Millcreek Planning Commission

OCTOBER 19, 2022

FC-22-004
SLOPE WAIVER
3733 S CHOKE CHERRY DR

RC-22-002
RCOZ C
4347 S GARDEN DRIVE

BASEMENT FLOOR PLAN

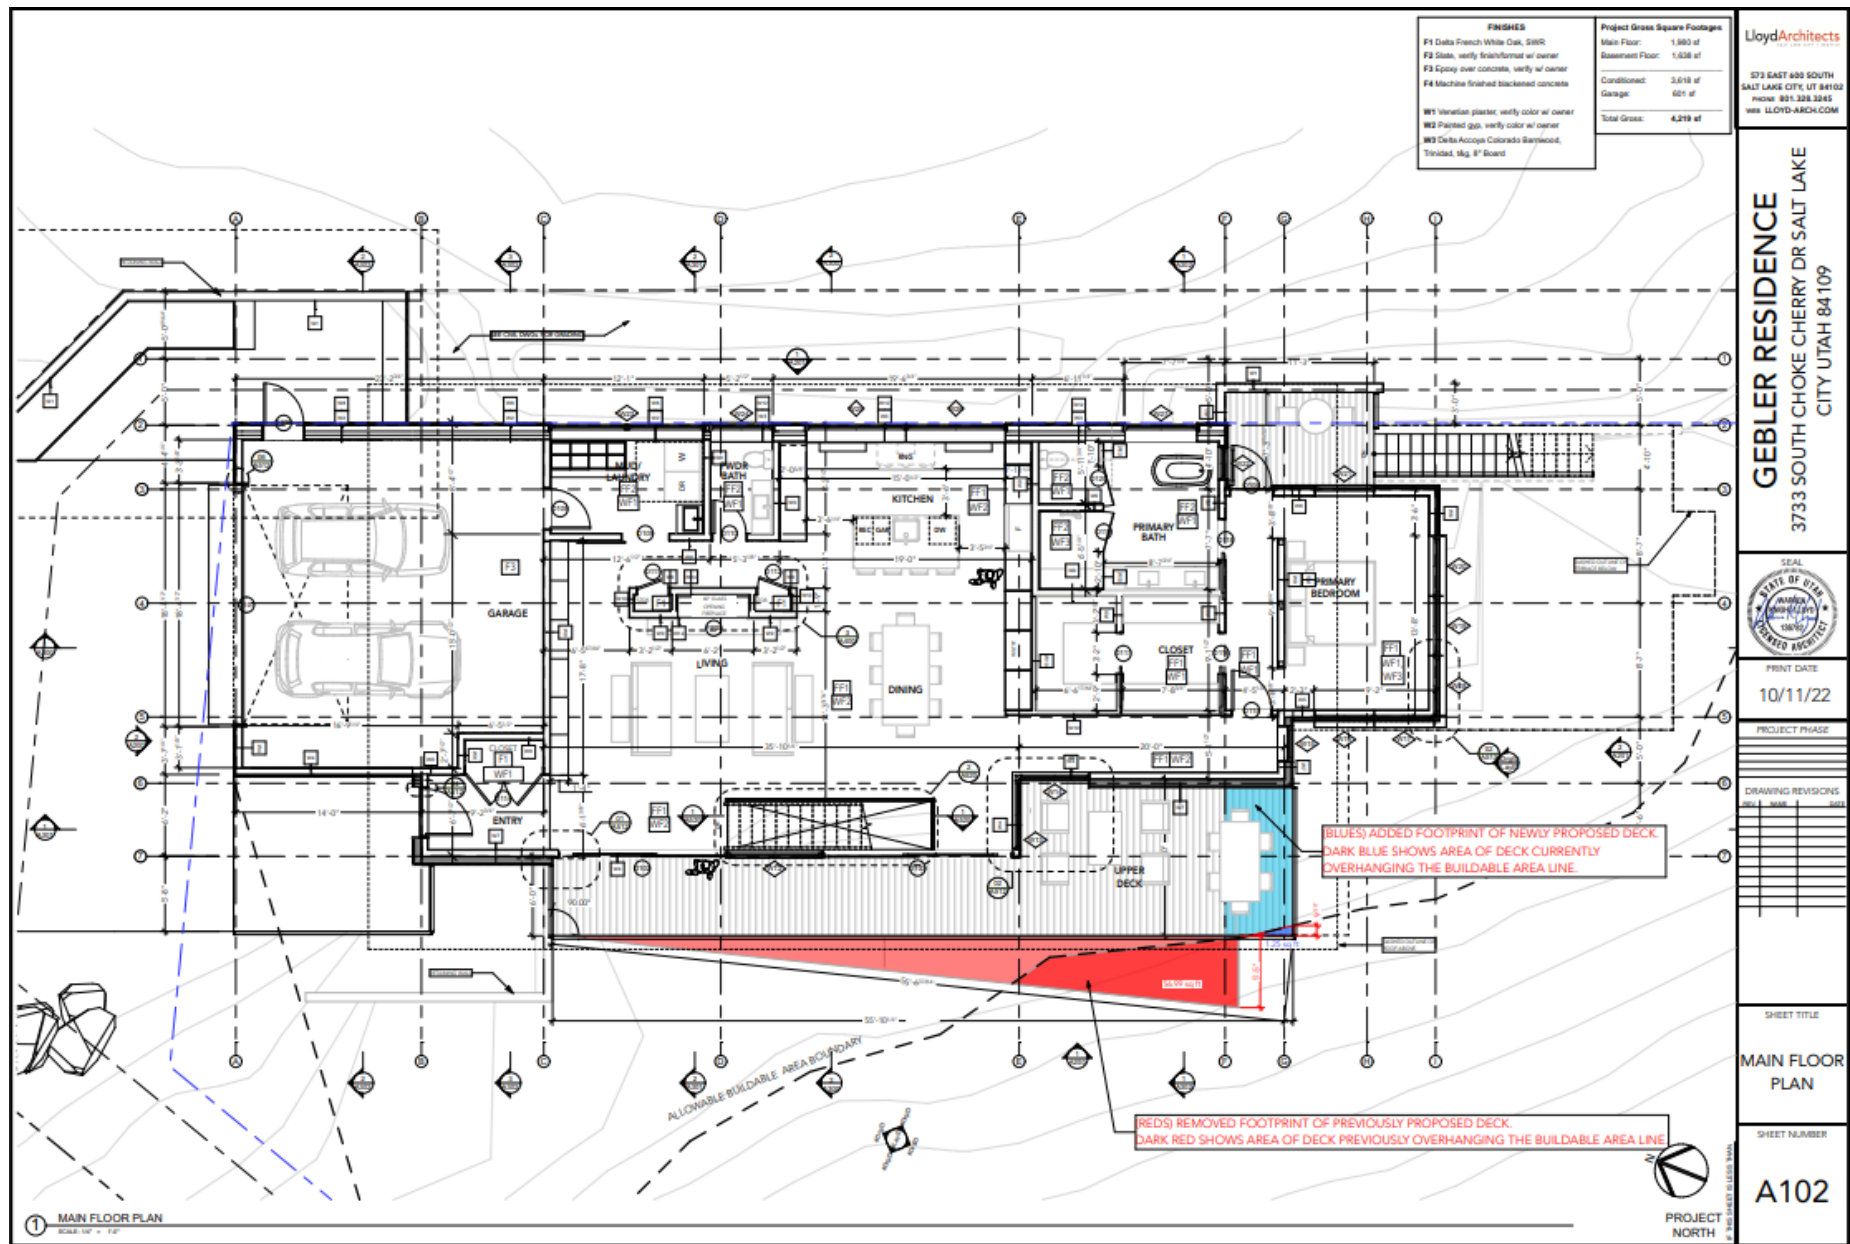
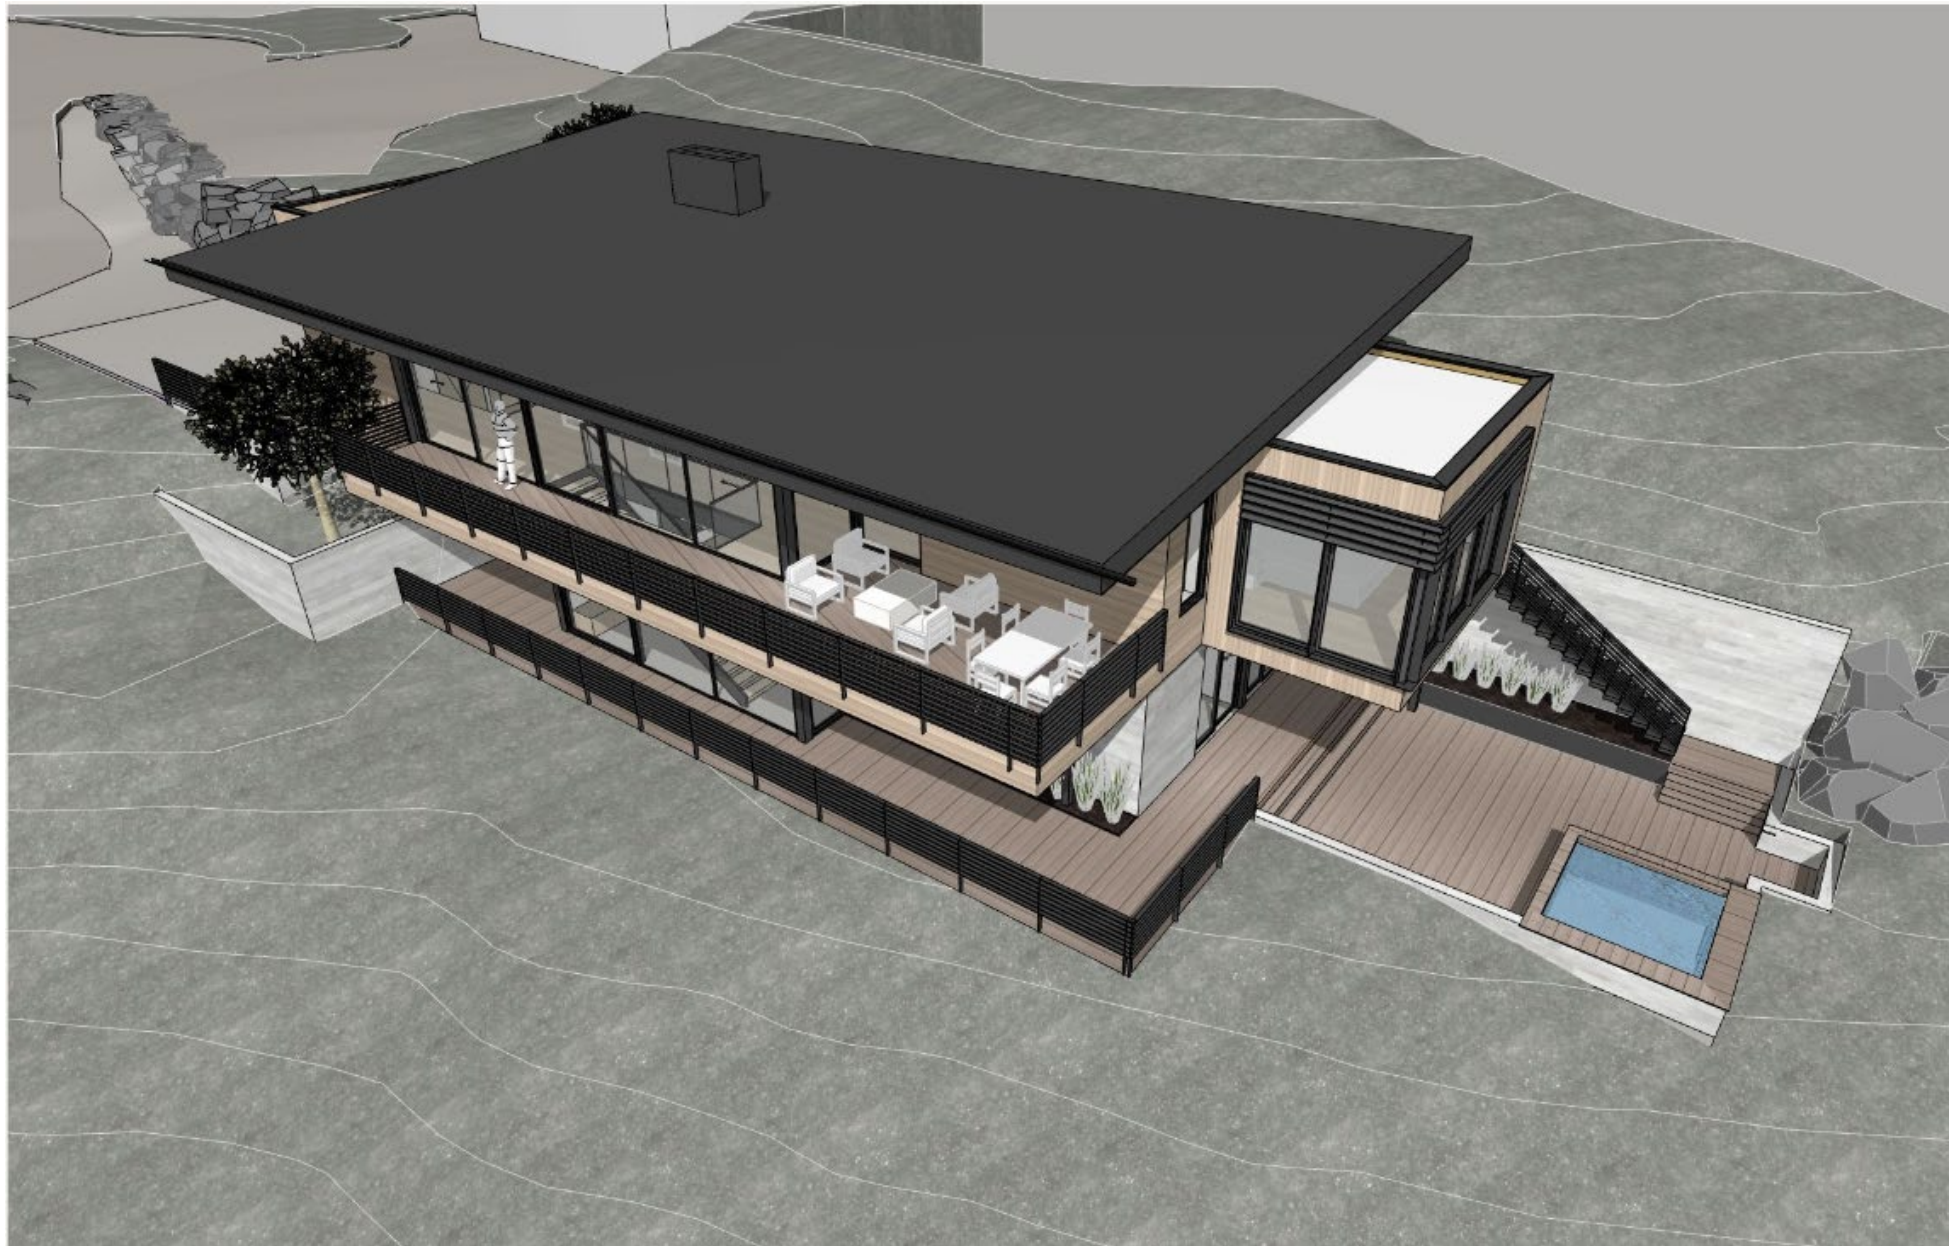
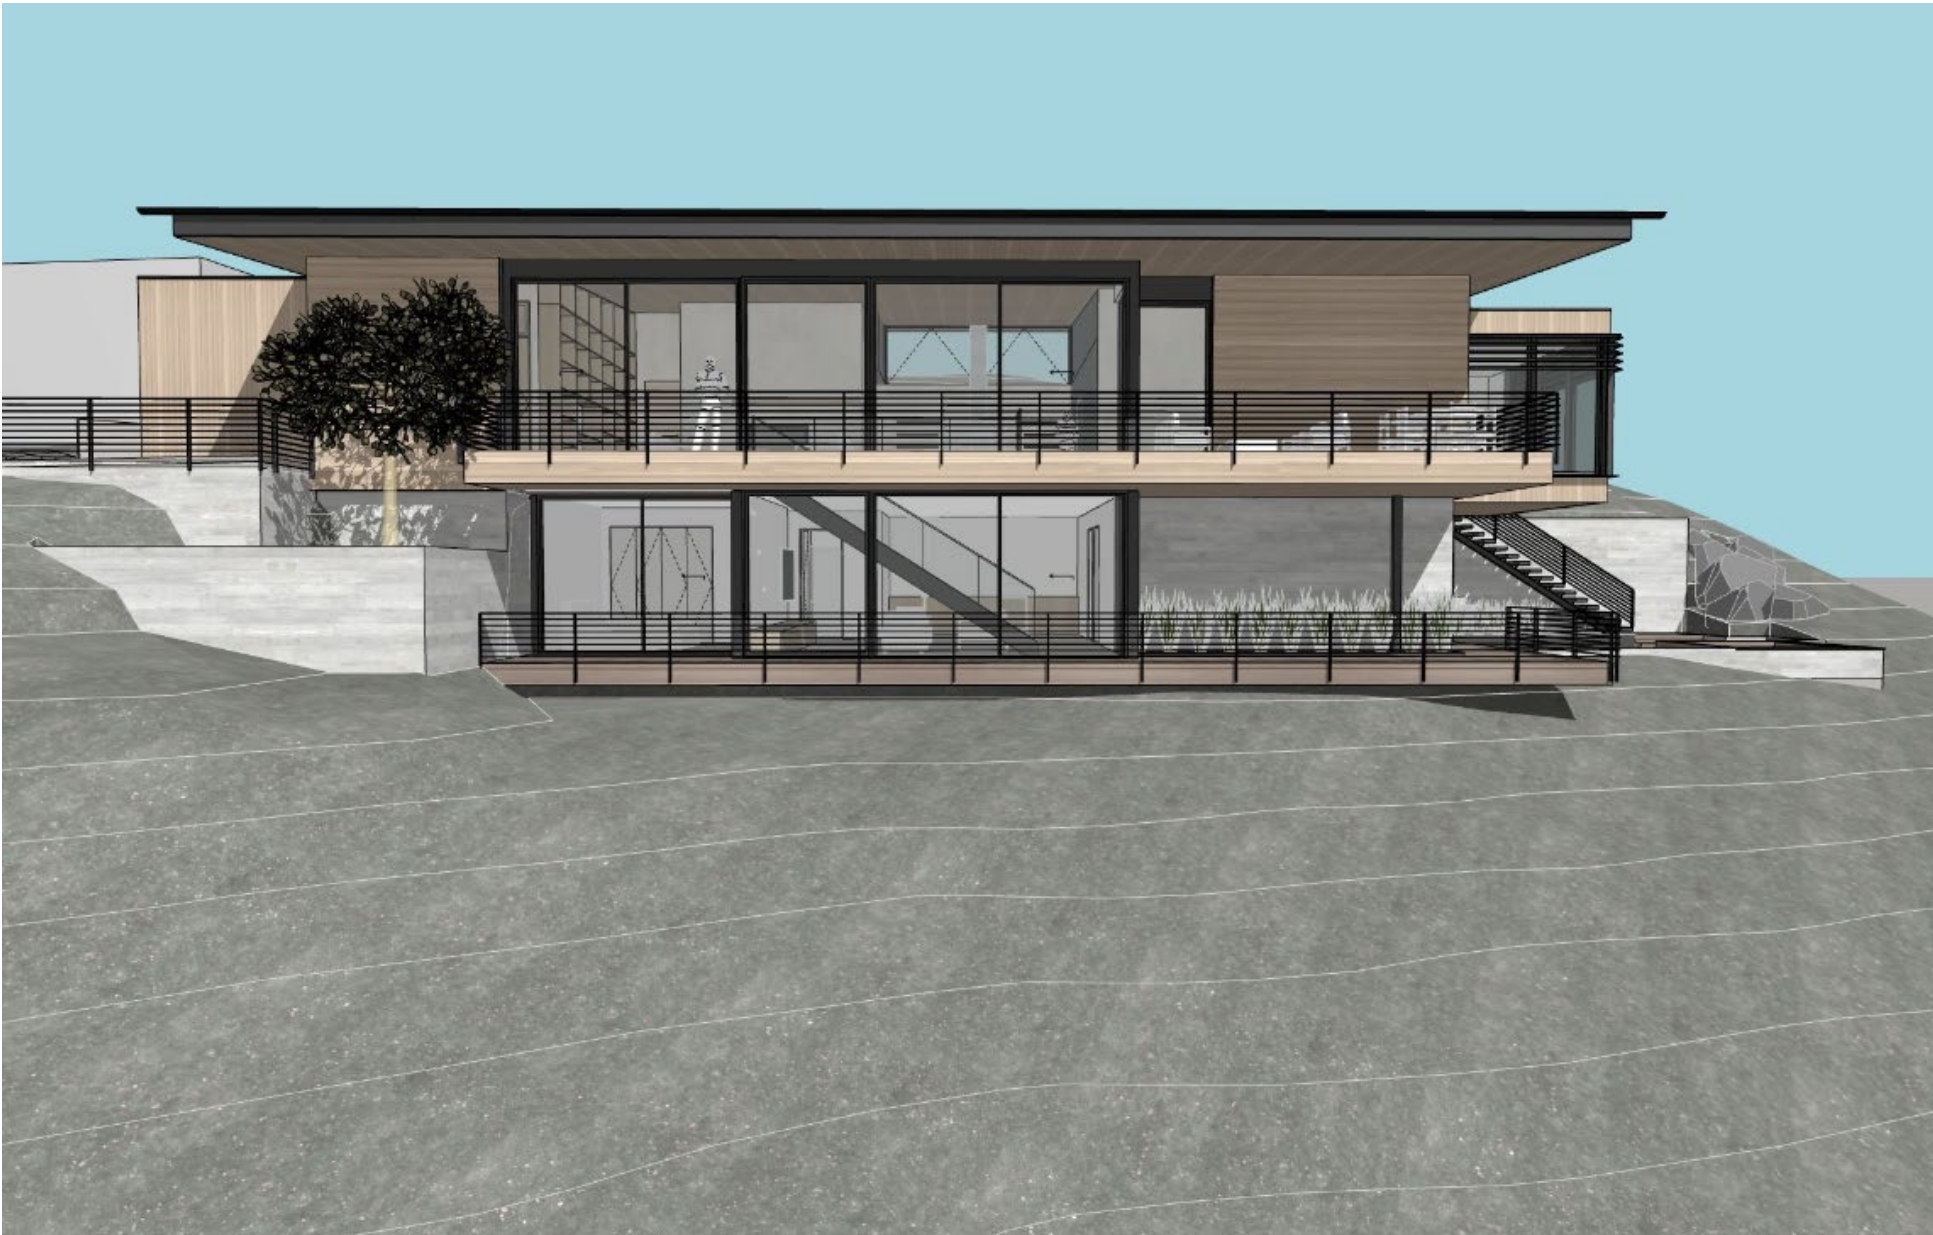
***Staff Comment:** Staff and the applicant worked through several iterations of the design of the home, with an intent to minimize its height and profile, and reduce its impact on slopes greater than 30%. The home is neither as tall nor as large or wide as many of the homes in the vicinity. The home falls below the maximum height allowed in the zone, and the roof is designed in a manner such that the home falls below the ridge line on the property to the east. The roof is sloped to parallel the contours of the site, where the slope gradually falls from east to west. The most prominent façade will be the south façade, facing Millcreek Canyon Road. It is two stories in height. The highest point of that façade will be 27 feet above original ground surface.*

1. Applicant should consider additional efforts to stabilize the fencing such as anchors into the native soil may be needed. The applicant's proposal for sandbags to be used for stabilization for construction is insufficient.
2. Applicant should supply a more detailed slope stability plan for constructions.
3. Applicant is proposing cantilevered decks as part of their projects. Cantilevers should be pulled back to fall within the limits of disturbance recorded on the plat.

Geologist and Senior Development Engineer feel that these are acceptable solutions, depending on the specifics once those are received. As far as the cantilevered upper deck sticking out, staff has asked the applicant's structural engineer for an explanation as to how this will be done without disturbing any ground outside of the limit of disturbance - especially if the LOD fence is placed on that boundary line.

WEST ELEVATION

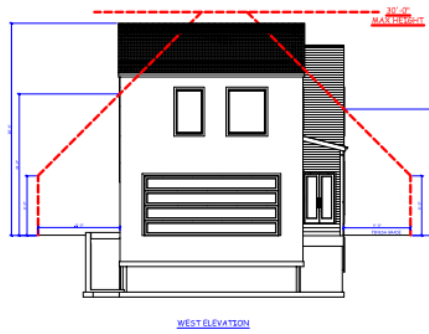
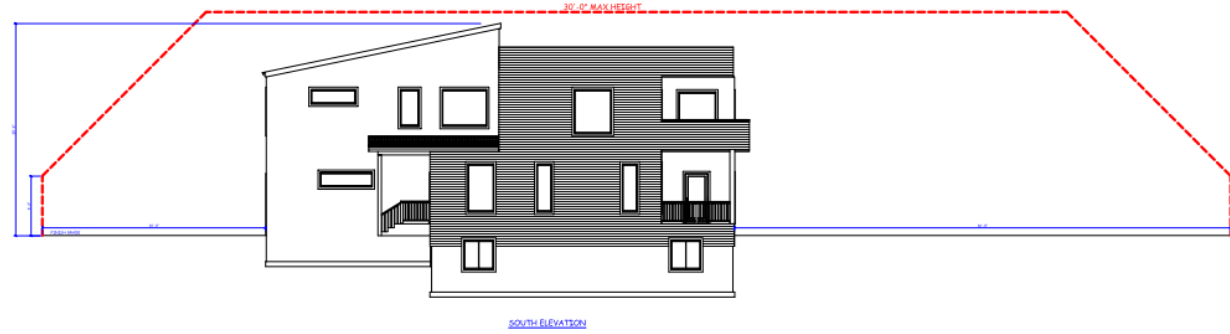
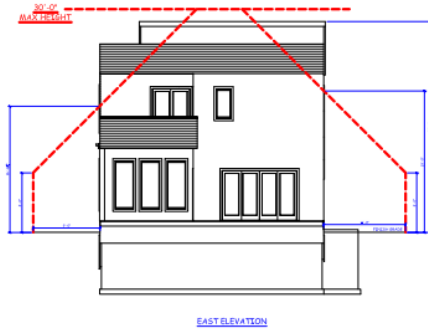
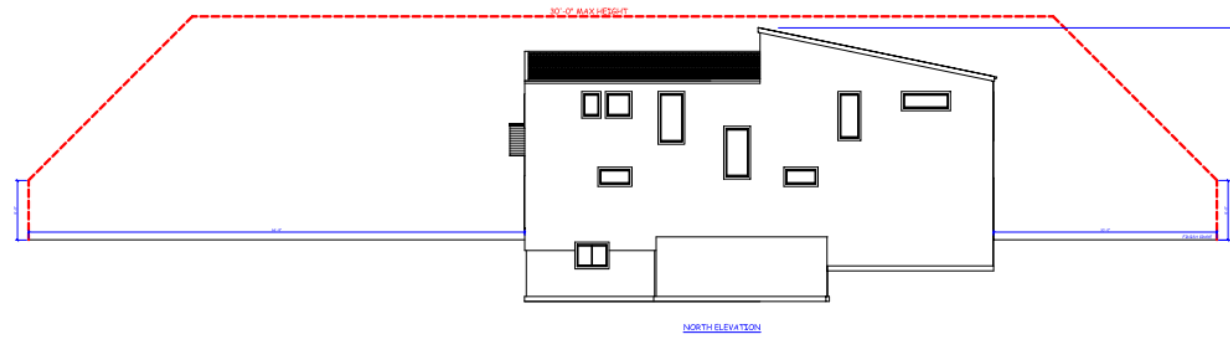
However, while the height of the proposed residence shows to be well under the maximum allowed height, the height of the structure shows to be further limited by the RCOZ building envelope.

The design of this home will not be affecting any neighbors' view to the west, east and south side, but there may be an argument that the design of this house could be reduced to fit the building envelope.

Staff requests that the applicant does not propose any modification that will further extend the building mass nor elevate the height of the building, to not only stay away from obstructing views but to also be in harmony with the neighborhood. Granting an exception should be conditioned on meeting these mitigation measures.
